Proposed Milton Quarry East Extension JART COMMENT SUMMARY TABLE – Natural Environment

JART Comments (December 2022)	Reference	Source of Comment	Applicant Response (Jan 2023)	JART Response
Repoi	rt/Date: Level 1 and 2 Natural Environment Technical Report (NETR) and Environ	mental Impact Asses	ssment (EIA) Dec	ember 2021 Author: Goodban Ecological Consulting	Inc. (GEC)

N:\Brian\9061DJ Dufferin - Milton Quarry East Extension\Drawings - Must be in NAD 27\Site Plan\CAD\9061DJ - Site Plan

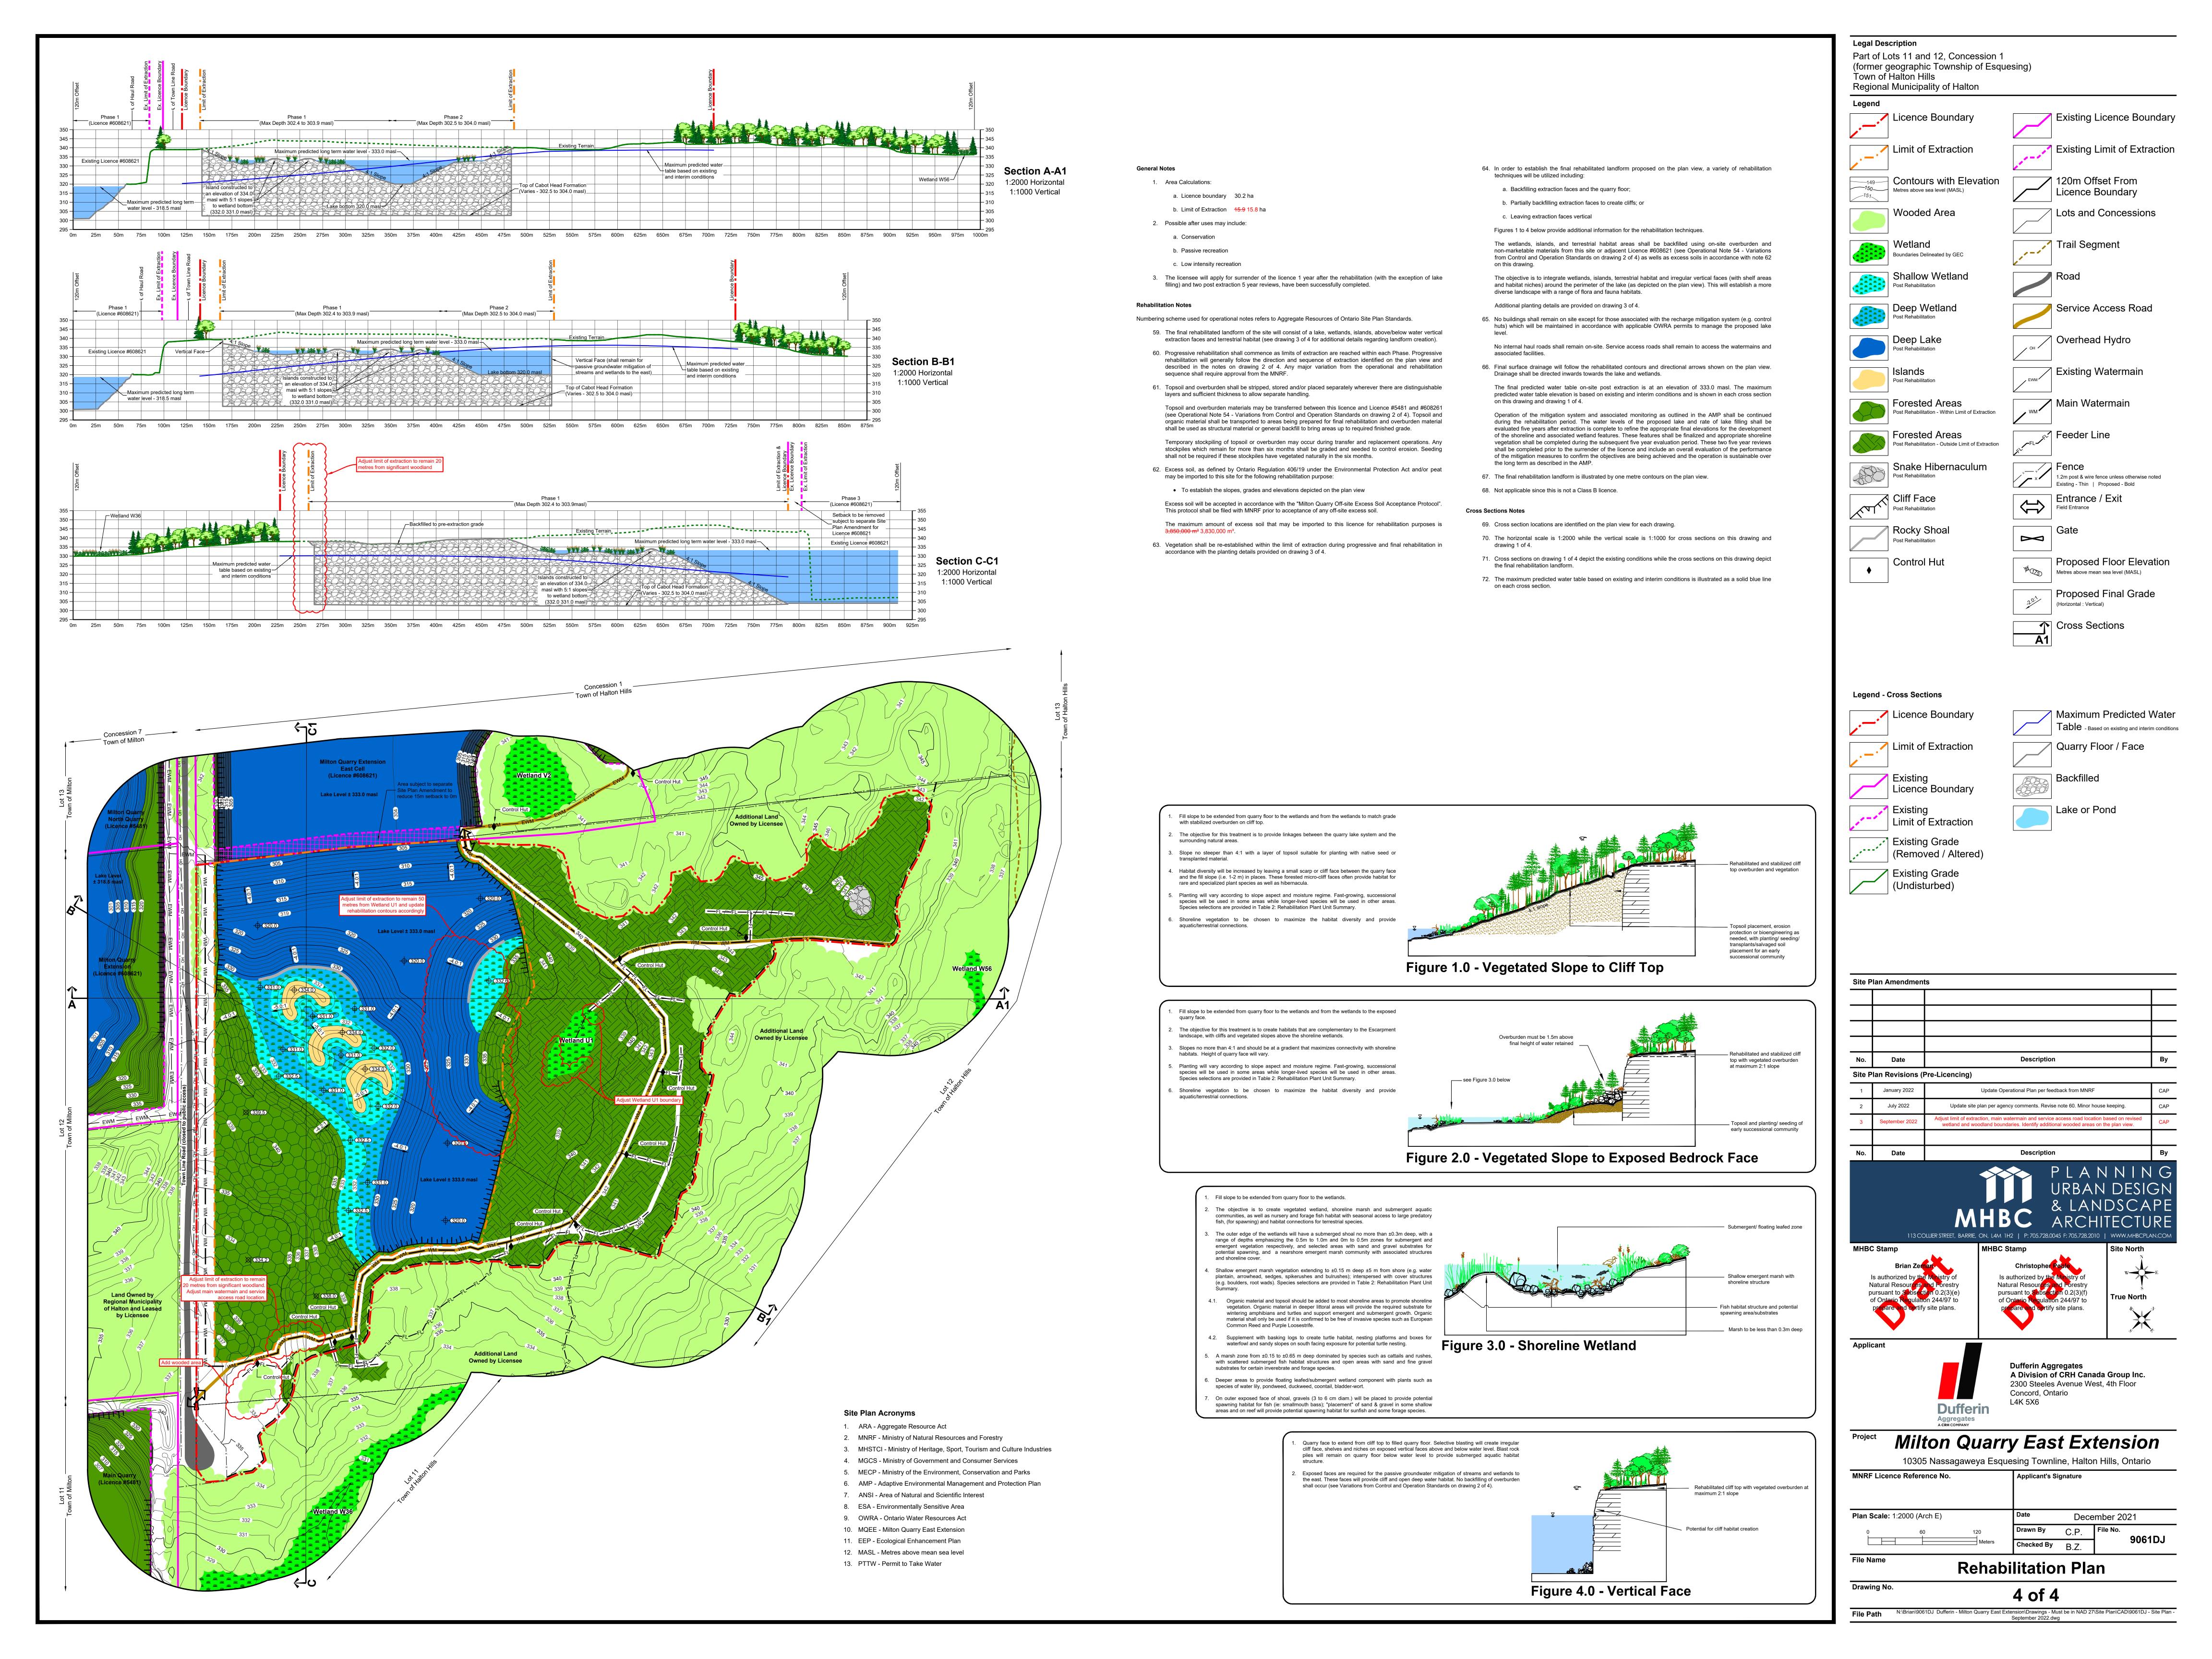
Section 7 provides an analysis of the provincial significance of wetlands in Ecoregion 6E. However, significance of wetlands in Halton Region should also be considered. Analysis of whether wetlands U1 and W56 would be considered significant according to Region of Halton criteria should be provided, in accordance with s.276.5(1) of the		Sarah Mainguy, NSE	Wetland U1 is already identified as a Key Natural Heritage Feature on Schedule 1G (Key Features within the Greenbelt and Regional Natural Heritage Systems) of the Region of Halton Official Plan.	
Regional Official Plan and in consultation with Conservation Halton and MNRF staff. - it is noted that these wetlands are being protected from extraction, with a buffer of 50 m, which is likely more than a Regionally significant wetland would be buffered.			As indicated in Dufferin's July 22, 2022, responses to ARA objection letters from the agencies, Wetland U1 is being treated as Provincially Significant for planning purposes. The ARA Site Plans were updated to reflect this.

See Tab A (Updated NETR & EIA Figures 31, 32, 34 and 35) and Tab B (Updated ARA Site Plans).	
			As indicated on page 75 of the NETR & EIA, Wetland W56 is a small, minor feature with a short, ephemeral

JART Comments (December 2022)	Reference	Source of Comment	Applicant Response (Jan 2023)	JART Response
28.	The boundary delineation for wetland U1 was completed on Wednesday, August 10 th with CH staff, North South Environmental, and Goodban Consulting. Minor modifications to Dufferin's previously staked wetland boundary were completed by moving some of the stakes to better represent the wetland vegetation community and establish CH's regulatory limits. A memo entitled, "MQEE Wetland Boundary Review – August 10, 2022 Site Visit" dated August 29th, 2022, prepared by Goodban Consulting was provided regarding the updated wetland staking exercise and adjusted boundary limit. Upon review of this memo, CH does not have any concerns and agree with the adjusted limit of extraction in response to the adjusted boundary limits for wetland U1. Update all drawings, report figures and the proposed site plan to accurately show the updated boundary limits for wetland U1 and revised limits of extraction.	Level 1 and 2 Natural Environment Technical Report and Environmental Impact Assessment	СН	The ARA Site Plans have been updated to reflect the minor changes made to the Significant Woodland boundary and Wetland U1 boundary resulting from the August 8 and 10, 2022, site visits. Please see Tab B for the updated ARA Site Plans.

Figure 1 – Buffers and Setbacks for Significant Woodland and Wetland V2

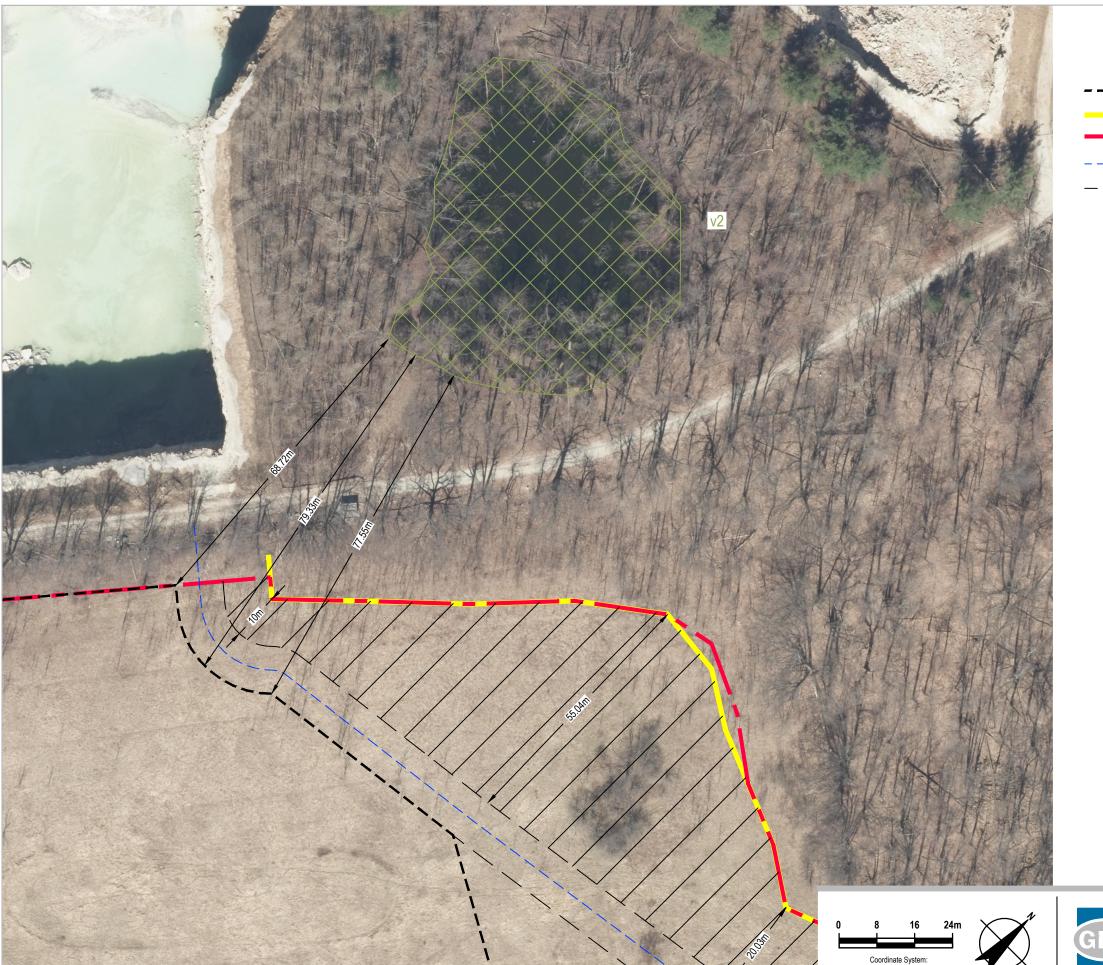
20.	Buffers Additional, detailed justification should be provided for reduction of buffers to the Significant Woodland on the southwest side of the extraction area on Page 173 (mapped on Figure 39). The Region OP Schedule 1G includes a 30 m buffer width from Key Features of the Regional Natural Heritage System (RNHS). Buffers are a component of the RNHS as per Section 115.3 of the ROP. Section 116.1 of the ROP allows for refinements and boundary adjustments to components of the RNHS, including buffers, through the submission of a study accepted by the Region. As part of the NETR, refinements to the 30 m buffer should be justified, including clearly illustrating the relationship between the buffer and the installation of the feedermain, recharge wells, control huts and the access road on more detailed mapping of this area.	Section 115.3 and 116.1	Sarah Mainguy, NSE	The following response is adapted from that provided in Dufferin's July 22, 2022, response to the NEC's April 26, 2022, objection letter. For mineral aggregate operations, planning policy does not require a 30 m buffer adjacent to Significant Woodlands. For example, Development Criteria 2.9.1 of the Niagara Escarpment Plan notes that mineral aggregate operations may be permitted in any vegetation protection zone. The buffer that has been recommended is a minimum of 10 m in width, plus an additional 10 m wide area to accommodate the WMS, e.g., watermain and access road, CV Huts, etc., resulting in a 20 m extraction setback to the Significant Woodland boundary that will protect the Significant Woodland from negative effects. The Ecological Enhancement Plan (EEP) includes a series of Significant Woodland buffer treatments. Units TP-B1 to TP-B6 are buffer planting areas that will be planted in the first two years after licence issuance (please refer to NETR & EIA Figure 39 for detailed mapping of EEP Units). The buffer planting areas are in proximity to the proposed MQEE extraction area and they provide a buffer for the Significant Woodland and/or other EEP planting areas. The species selected for this purpose are White Birch (Betula papyrifera), White Cedar (Thuja occidentalis), White Pine (Pinus strobus) and Trembling Aspen (Populus tremuloides). These pioneering species have all colonized newly created cliff rim habitats at the Milton Quarry and Acton Quarry, along the edges of former extraction areas, and they are well suited as buffer plantings. Existing suitable woody vegetation within the 10 m buffers will be retained.

In accordance with Section 116.1 of the ROP, the reduction in the 30 m b for the woodland adjacent to wetland V2 should be justified in detail. appears to have a high function, that is protected by the surrounding woodlands adjacent to wetland V2 should be justified in detail.	This pond	Sarah Mainguy, NSE	Please see response to Comment 20. As shown on Tab D , Figure 1, at the closest points to the MQEE extraction footprint, Wetland V2 is located between 68 m and 79 m away. This means Wetland V2 has a 58 m to 69 m buffer, plus an additional 10 m setback. As noted in the response to Comment 20, only a very small portion of the Significant Woodland buffer is at the minimum 10 m width, with the remainder being up to 55 m in width in this general vicinity. It should also be noted that where the 10 m minimum buffer was applied, the Significant Woodland comprises a row of mature trees that were formerly in a hedgerow, as well as some deciduous regeneration that has spread into the former agricultural field. This can clearly be seen on the aerial photograph used for Figure 1 in Tab D .

The 10 m Significant Woodland is the <i>minimum</i> buffer that will be applied. The Significant Woodland boundary on the MQEE property is approximately 2340 m in length. The 10 m buffer applies to only 215 m of the Significant Woodland boundary (see Tab D , Figures 1 and 2). The edge of the Significant Woodland in these areas is well established and no new woodland edges will be created.	
	As shown on Tab D , Figure 1, only a very small portion of the Significant Woodland buffer is at the minimum 10 m width, with the remainder being up to 55 m in width in this general vicinity. It should also be noted that where the 10 m minimum buffer was applied, the Significant Woodland comprises a row of mature trees that were formerly in a hedgerow, as well as some deciduous regeneration that has spread into the former agricultural field. This can clearly be seen on the aerial photograph used for Figure 1 in Tab D .
